August 19, 2014
BOARD OF COUNTY COMMISSIONERS
ORANGE COUNTY, FLORIDA

ADDENDUM NO. 7
IFB NO. Y14-748
ORANGE COUNTY EASTERN WATER RECLAMATION FACILITY
PHASE V AND CENTRIFUGE DEWATERING IMPROVEMENTS

PLAN
 SCALE: 3/8" = 1'-0"

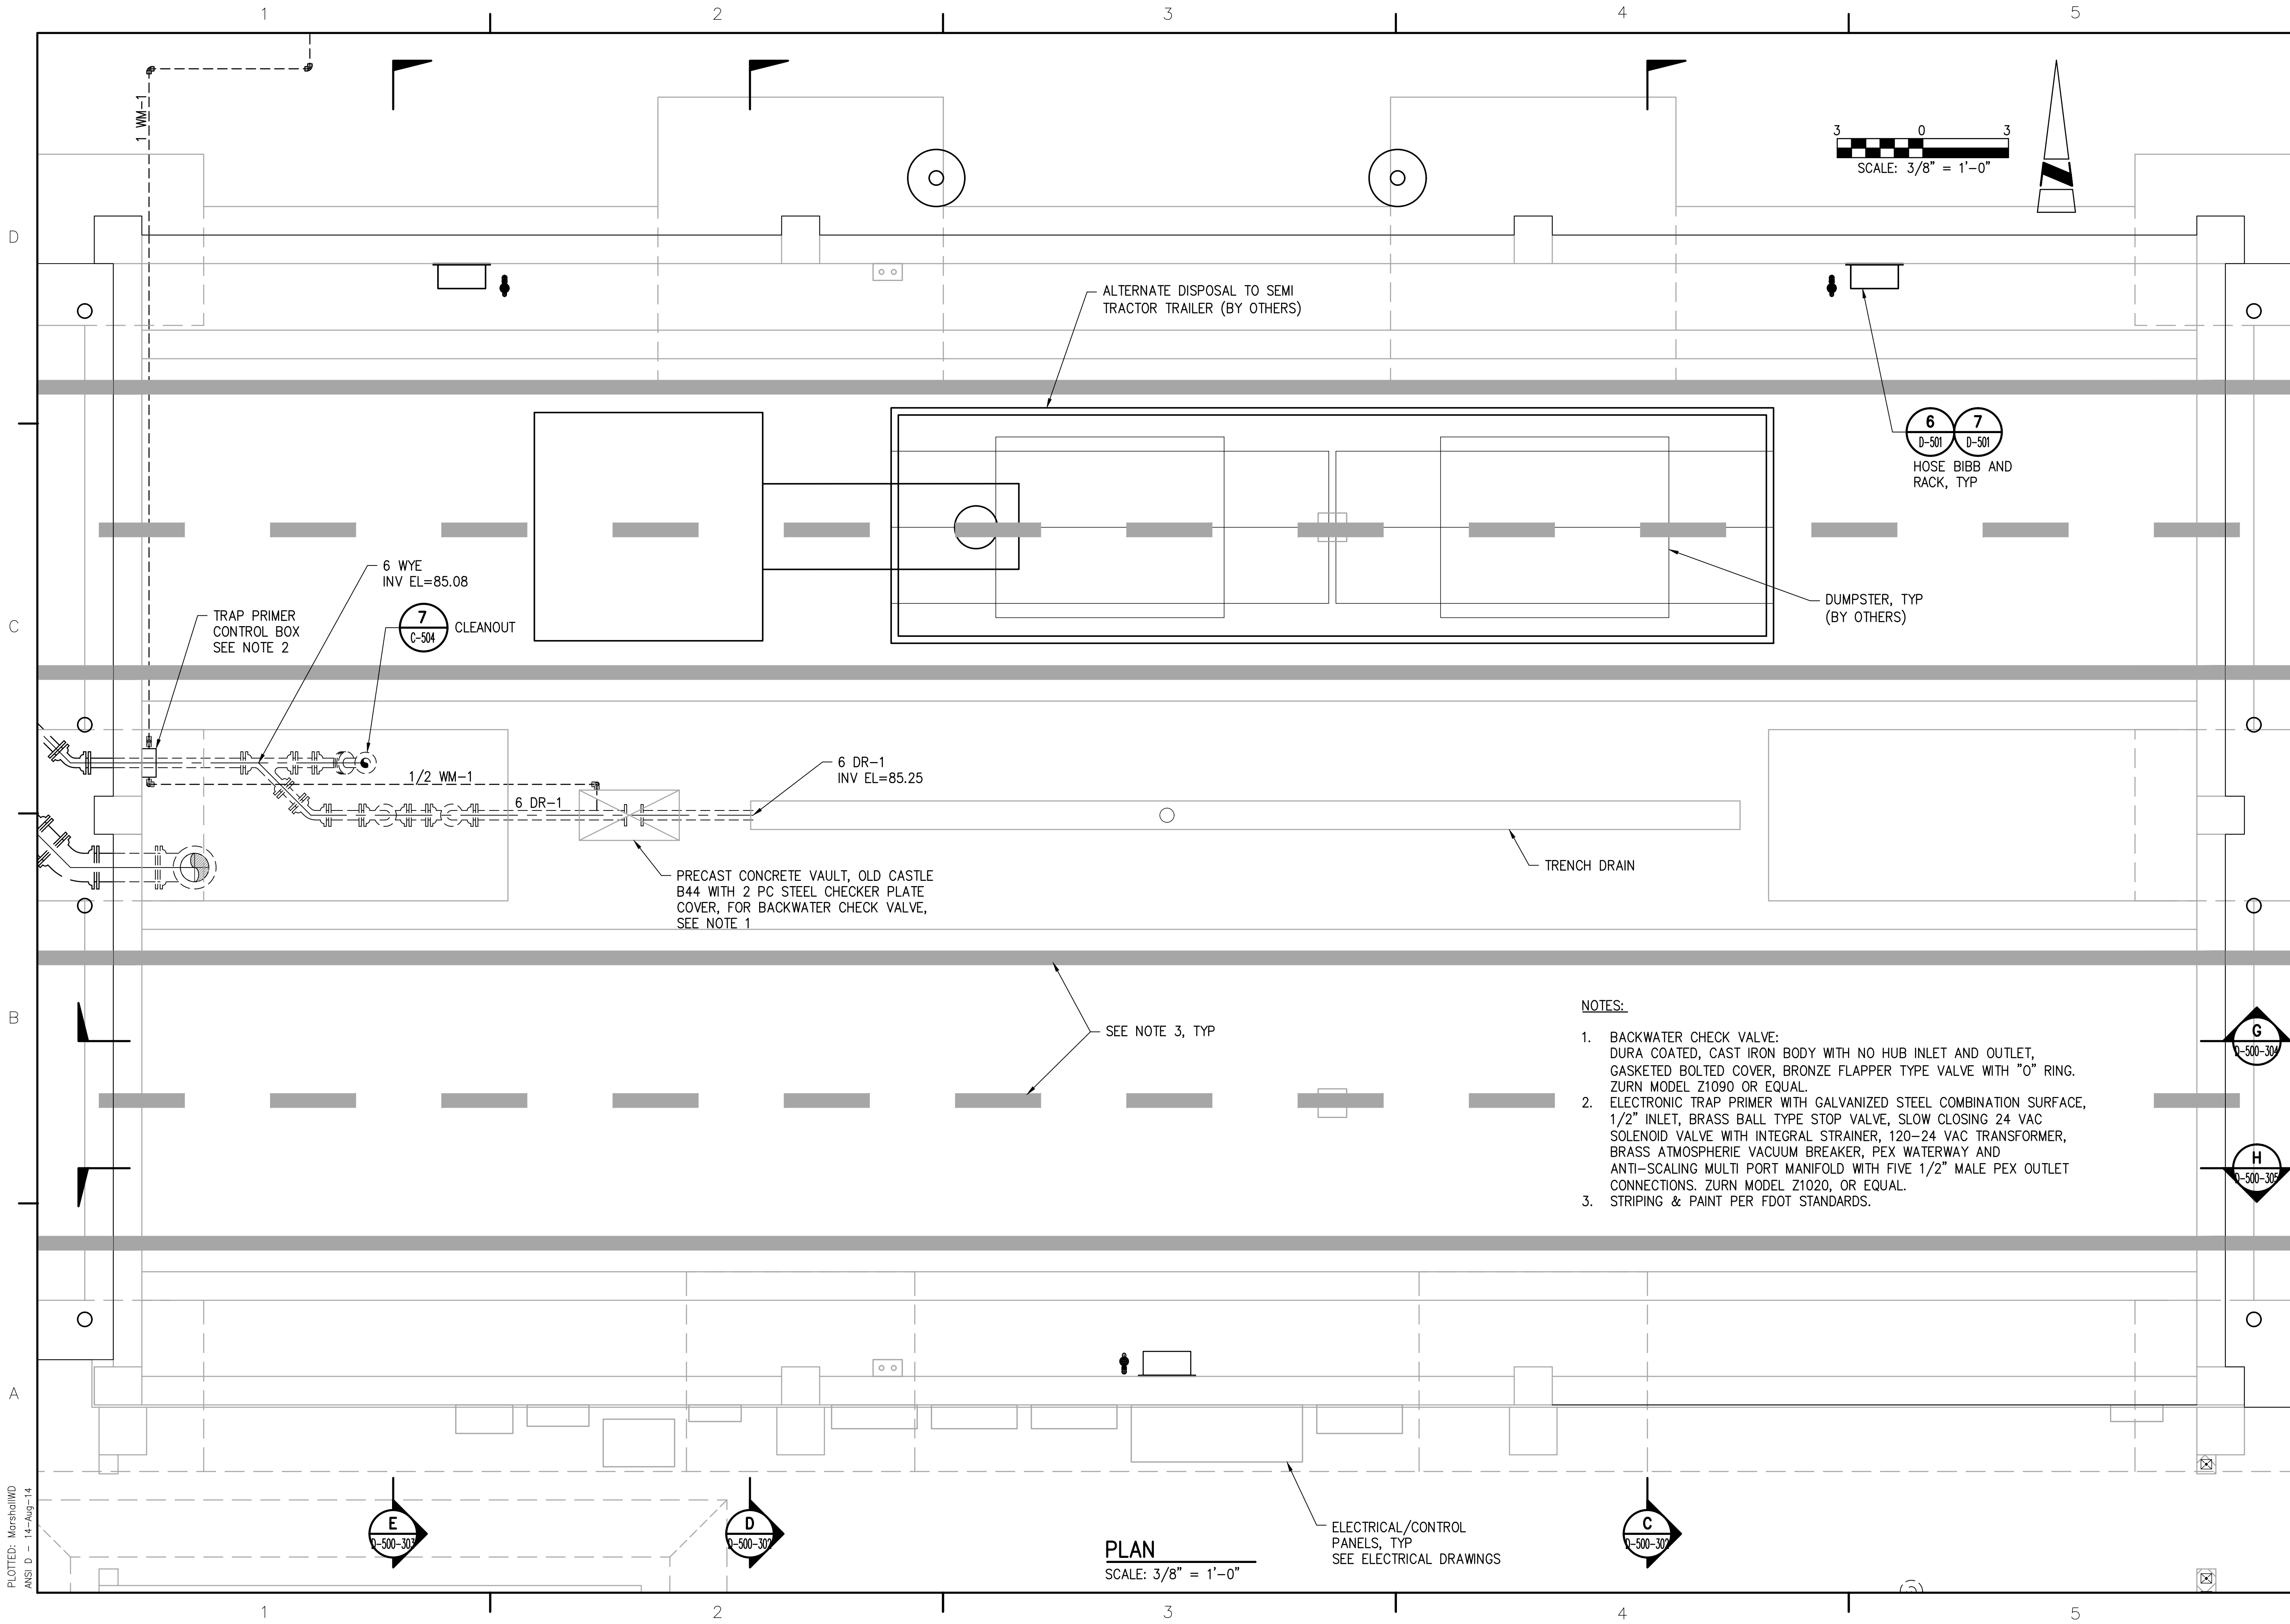
22. Bid Package A, D-500-105 there is a Trench Drain Shown. On drawing S-500-105 and S-500-302 the Trench Drain is called Polydrain Trench. There isn't any specification for this drain and related grating. Would you please provide them?

23. Bid Package A, Drawing S-500-105 the poly drain is shown as being 34'8" long. On drawing D-500-106 it scales 52'0" long. What is the actual length of the trench drain?

Reference Addendum 6, Bidder Questions 99 and 127 which included revisions to Drawing S-500-105. There is no specification for the trench drain. Please provide trench drain as shown on the revised Drawing S-500-105 issued in Addendum 7. In addition, the trench drain shall have slotted stainless steel grating with invert sloped to coordinate with outlet piping shown on sheet D-500-105.

*It is 34'8". Please also reference Addendum 6, Bidder Questions 99 and 127 which included revisions to Drawing S-500-105. The trench drain and associated piping is not shown on sheet D-500-106 but rather on sheet D-500-105. The trench drain is drawn correctly to scale at 34'8" however the scale below "Plan" was 1/4"=1'0" and was corrected to be 3/8"=1'0". A manufacturer's product has been specified for the "vault" where the backwater check valve and trap primer injection are located (**Attachment**).*
